Technical Note
PCC Highways Comments Response
Land at Peterborough Road, Farcet

Project Number: 24482
Doc Number: TN13
Prepared for: Hallam Land Management Ltd & Persimmon East Midlands

13 February 2026

Figure 1.1 Proposed Interim Mitigation Scheme

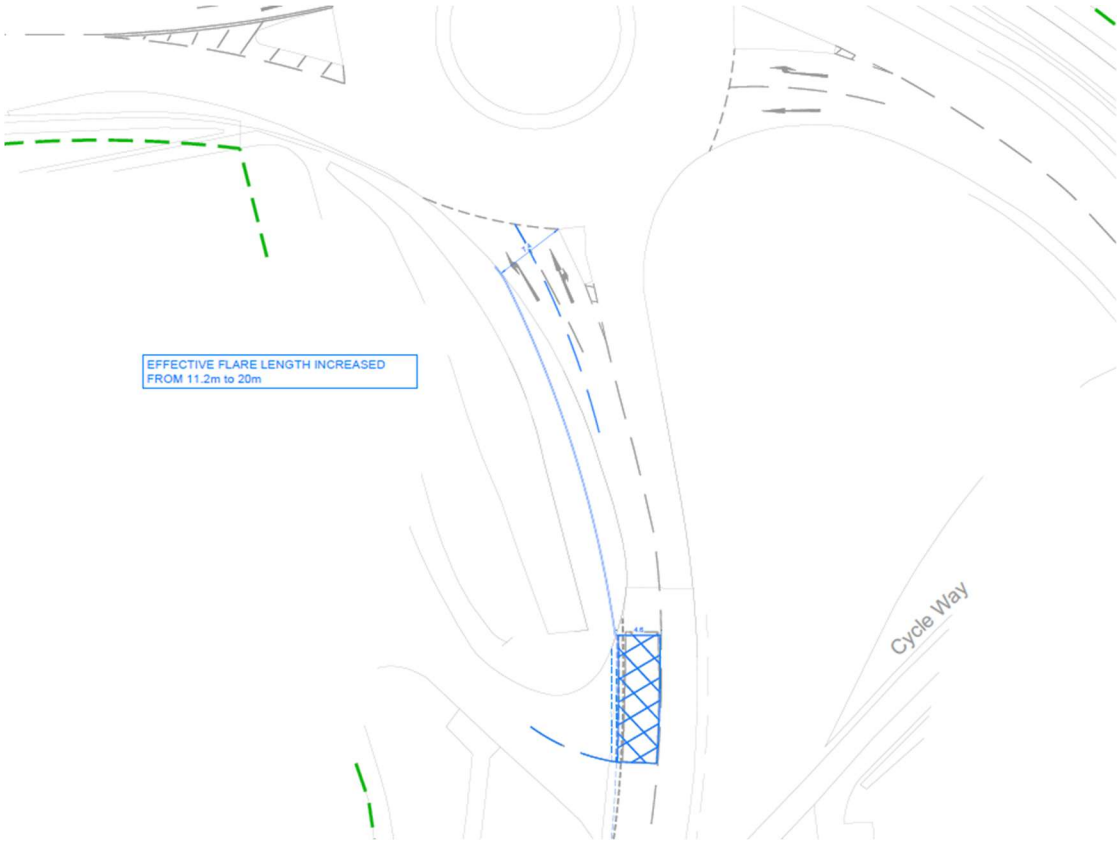
1.4.1 The proposed development has a very localised impact at the junction, namely on Peterborough Road south in the AM Peak. A potential alternative scheme that seeks to mitigate this impact and reduce the queueing on this arm back down to the level anticipated in the future base scenario, which is within operational capacity has therefore been considered.

1.4.2 The proposed scheme would widen the approach by extending the two-lane section to provide an effective flare length of 20m (compared to the existing 11.2m). The width of the carriageway at the entry point of the roundabout would remain the same.

1.4.3 The proposed layout is shown below and included at Appendix A and demonstrates that all works can be delivered within the extent of adopted highway.

1.4.4 Capacity testing of this scheme has been undertaken and the results are summarised in **Table 1.2** below.

1.4.5 The results show that the impact of the development would be mitigated in all future with development scenarios and the junction would return to operational capacity, with a ratio of flow to capacity (RFC) of 0.83 and a queue of 4.6 PCUs in the 2035 AM Peak scenario, which is lower than the Future Base + Committed Development scenario for the existing junction. The model outputs are included at Appendix B.

PETERBOROUGH ROAD ROUNDABOUT
CAPACITY IMPROVEMENT
(WITHOUT UTILITIES)

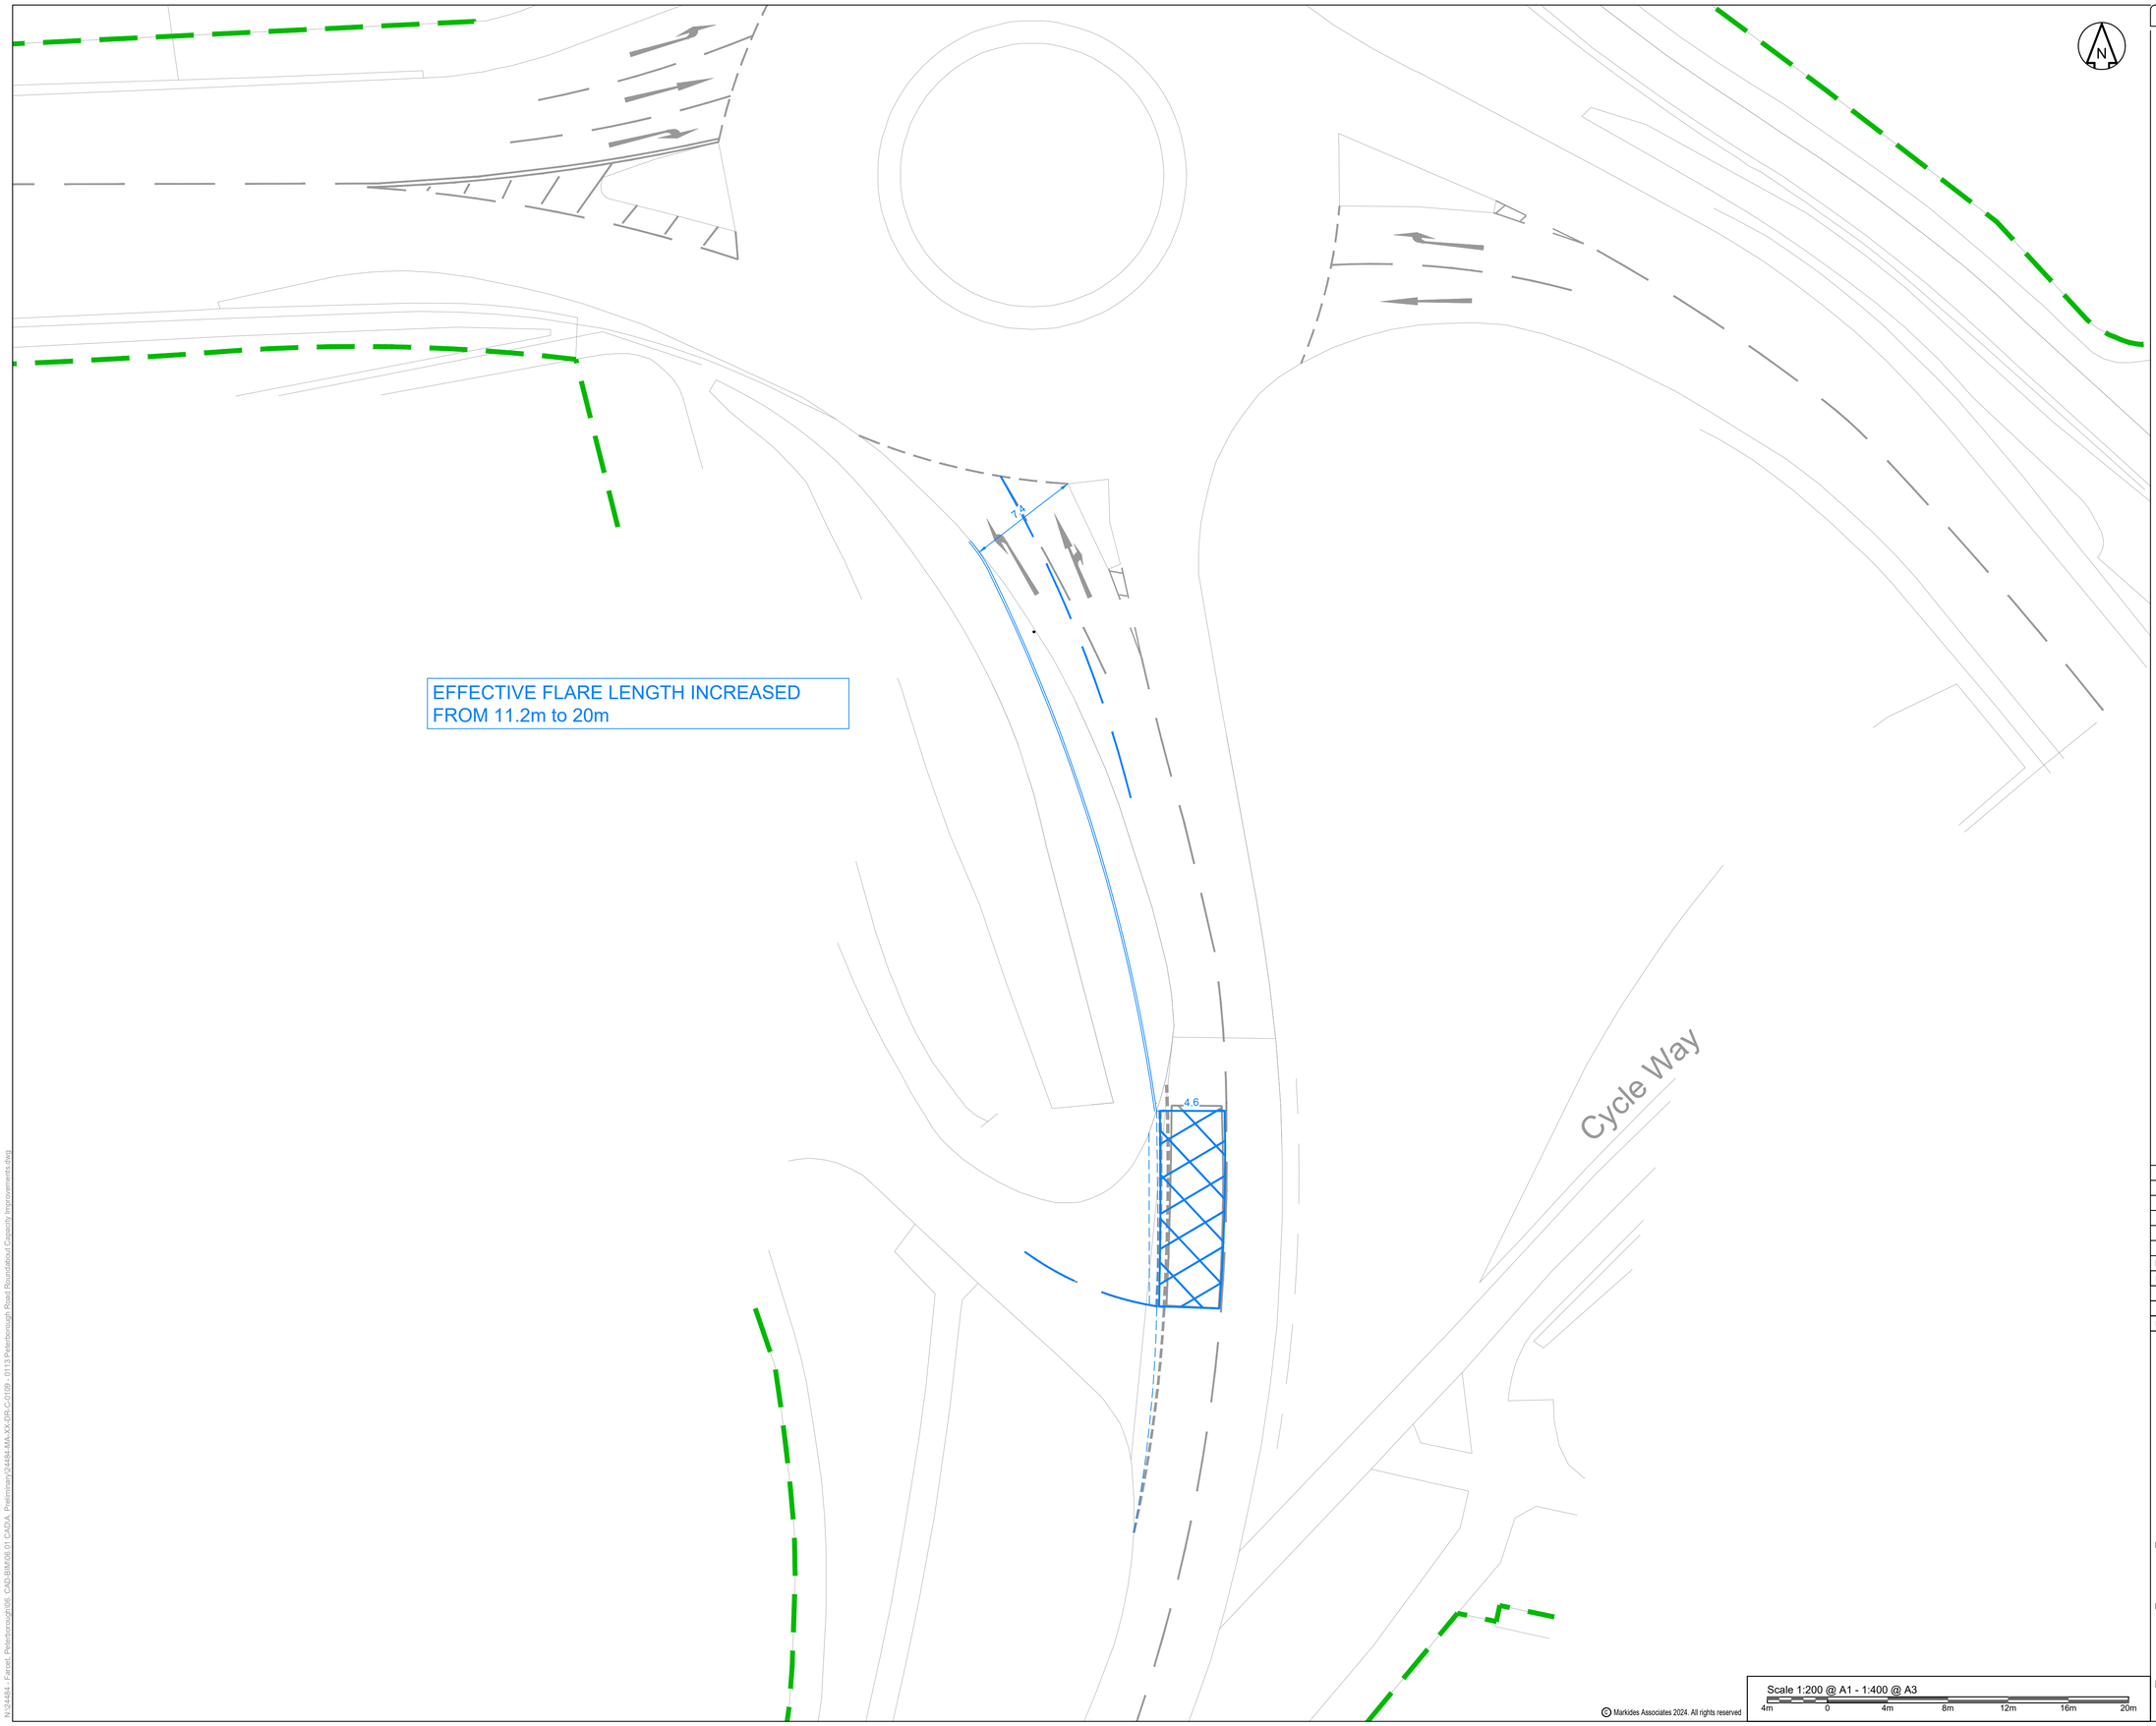
1.5.3 We have considered an alternative arrangement that widens the southern arm the junction. The capacity results indicate that this would mitigate the impact of the development, when assessed using a robust level of trip generation and the junction would operate within capacity with queues similar to the existing scenarios.
